AGENDA

Village of Chenequa Plan Commission
Monday, December 9, 2024 at 6:00 p.m.
31275 W. County Road K, Chenequa, WI 53029

STAFF REVIEW

Project Description: Proposed Single-family Dwelling and Landscape Plan

Updated Grading Plan to Reflect Recent Grading Activities

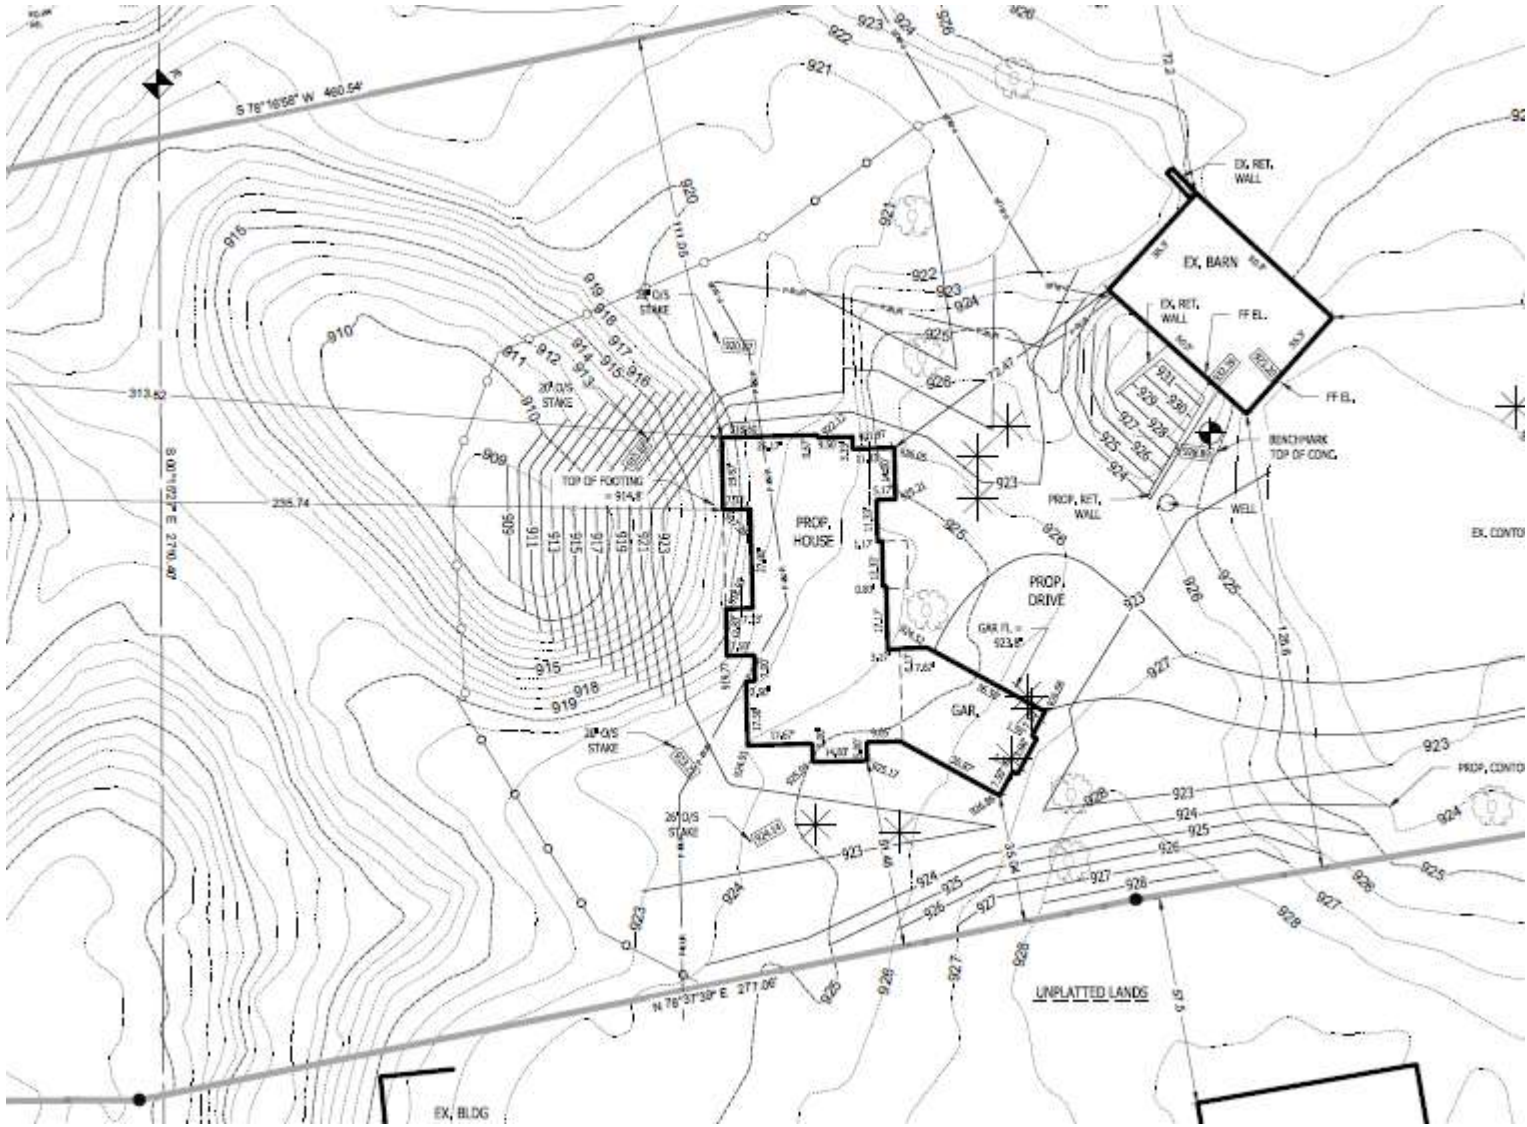
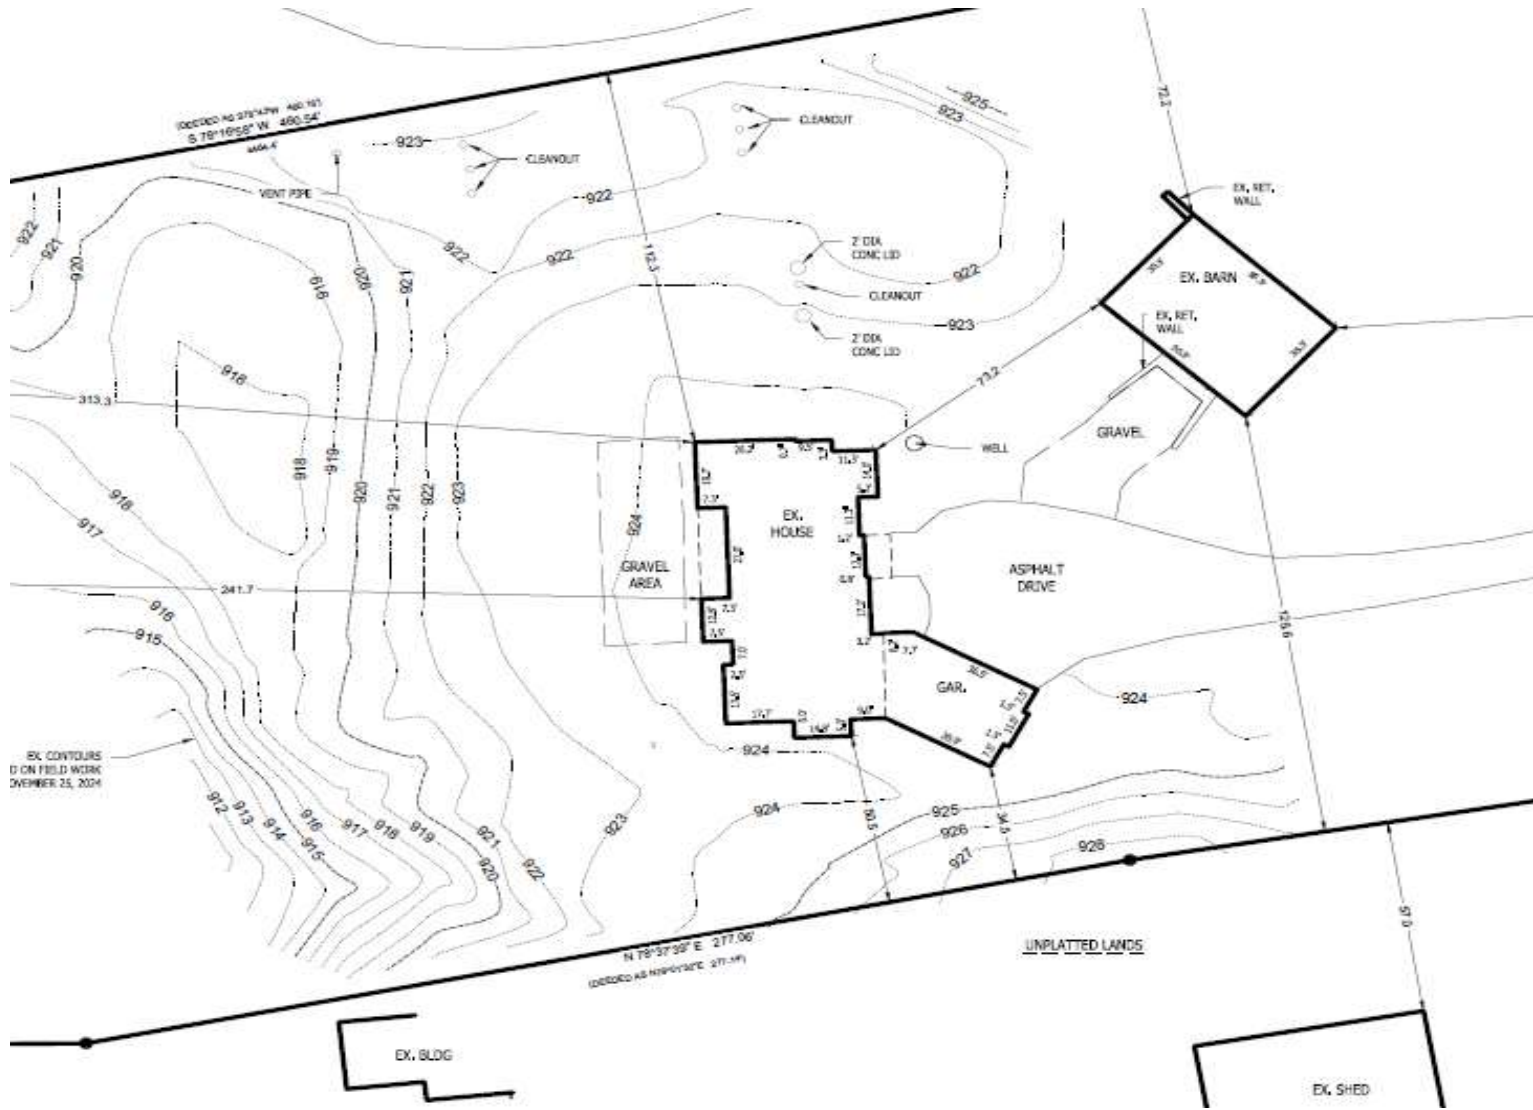
In March of 2023, Kent and Renee Haefs received approval from the Village board for the construction of a primary residence at 4779 N Pine Meadows Lane. Included with the house plans were the grading plans that were also approved. Recent grading on the property has deviated from the previously approved grading plan. As a result, the applicant is resubmitting a grading plan that reflects the grading work that was completed on the property.

In addition to the updated grading plan, the applicant is also seeking permission to install a concrete patio that is 18' X 50' (Approximately 900 square feet). This patio is 150'+ from the ordinary high-water mark of Pine Lake.

A copy of what was previously approved and what requires approval has been included in the packet.
